STAGES 4 & 5

MIXED USE DEVELOPMENT

ARCHITECTURAL STATEMENT

PART 2 : RESPONSE TO THE URBAN DESIGN REVIEW PANEL (UDRP) RECOMMENDATIONS (April 2021)

GFA Table

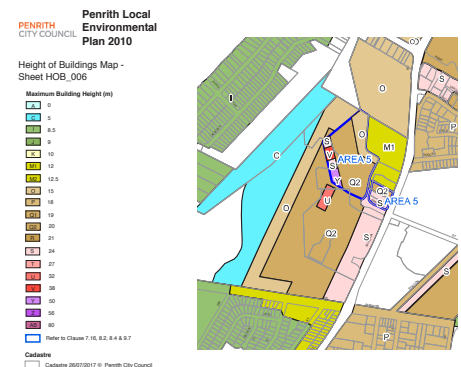
Comment 02 by UDRP: GFA

It was noted that the Penrith Local Environmental Plan 2010 has been recently amended to revise the maximum permitted height of building allowances for the site as well as key provisions relating to floor space ratio, unit occupancy rates and gross floor area allowances. The key provisions that now apply are contained within Part 9 – Penrith Panthers Site and as follows:-

- Likely maximum gross floor area allowance for Stage 4 and 5 being 38,698 sqm
- Likely maximum 382 residential apartments / units for Stages 4 and 5

The presentation eluded to compliance with the above provisions however the application will need to be supported by calculations across Stages 1 – 5 which confirm compliance. This also includes address of the objectives of Part 9 of PLEP 2010 as detailed within Clause 9.1

The GFA table below provides a breakdown of each stage to demonstrate compliances in overall GFA (capped at 80,400sqm) and apartment numbers (capped at 850)

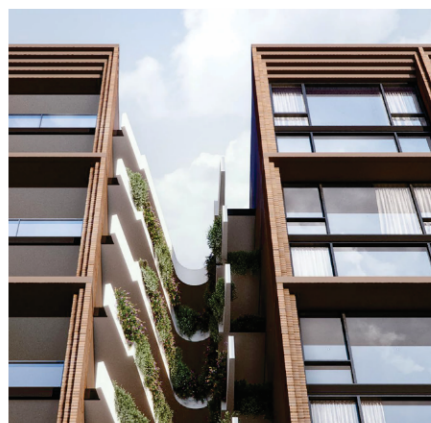
Comment 07 by UDRP: Projecting Pool

The projecting lap / swimming pool has the potential to impose on the ground plane as the photomontage on Drawing No. 14064 6.1.3 Revision A suggests a heavy mass projection which is lower than the awning. Further the amenity and privacy of adjoining residential units to the pool will need to be considered and treated.

Extent and massing of the lap pool has been pulled back from the facade as demonstrated on the architectural plans, privacy against the adjacent apartment has been provided via screening.

Breezeway Ventilation Diagram

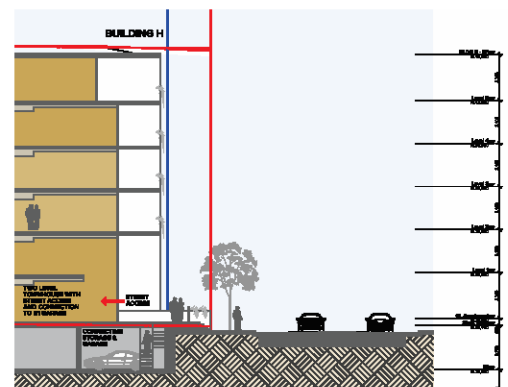
Comment 04 by UDRP: Breezeway Ventilation

The curvilinear indents / slots within the elevations provide for an interesting architectural streetscape response however where relied upon for cross ventilation, the separation is critical and the drawings will need to ensure that cross ventilation is achievable.

Curvilinear indents with breezeway provides articulation into the building, landscaping and natural ventilation for the communal corridor as well as cross ventilation for the apartments as demonstrated by the diagram below. This breezeway also respond well in cooling the building and the communal space.
